Service Bulletin

Bulletin No: 46 004 04 (024)

Topic: Center stand of the F 650 GS model when fitted with the lowered suspension option.

Subject: The center stand of the F 650 GS model, when fitted with the lowered suspension option, may contact the ground while riding at slight angles.

Picture 1

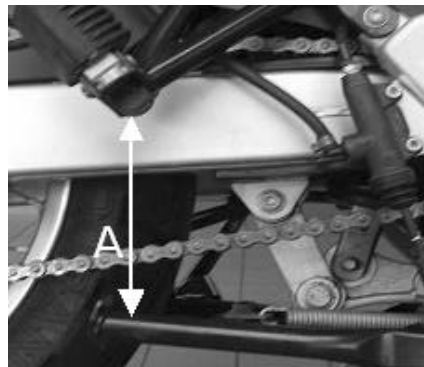
Distance "A" : Clearance between right footrest and center stand tube.

(**A**<170 mm or 6.69 inches)
Center Stand is good and does not require replacement.

(**A**>170 mm or 6.69 inches)
Center stand needs to be replaced.

Service Solution: F 650 GS models within the following VIN range, that are equipped with the lowered suspension option, will need to be checked as described below the next time that they are brought in for service. New center stands will need to be installed on motorcycles not meeting the required specifications.
